Interior - Seat Cushion Rocks Makes Cracking Noises

Order No.: P-B-91.10/83

Model 210.020/025/055/065/070/072/074/082/083/265/282

Seat Cushion Rocks When Braking and Accelerating or Makes a Cracking Noise

Figure 1

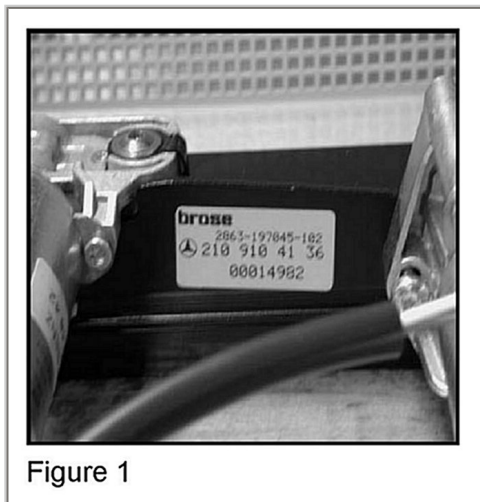
If you receive customer reports in the above model vehicles that the front of the seat cushion rocks when braking and accelerating or makes a cracking noise, this may be caused by excessive clearance for the stepped bolt. To resolve, install replacement bolts with an O-ring which are available as spare parts for seats with the height adjustment mechanism manufactured by Brose. A label identifying the seat height adjustment manufacturer can be found on the mechanism (Figure 1).

Figure 3

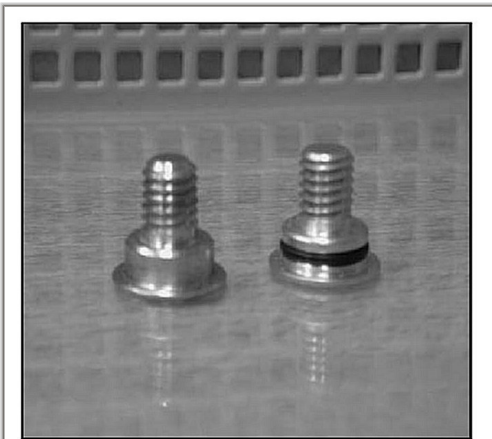
4. Remove original bolt (Figure 3, left bolt) and replace with new bolt with 0-ring (Figure 3, right bolt) on both the door side and tunnel side of the front seat together with a new crimp nut.
5. Reinstall affected seat following WIS document AR91.10-P-1000F.
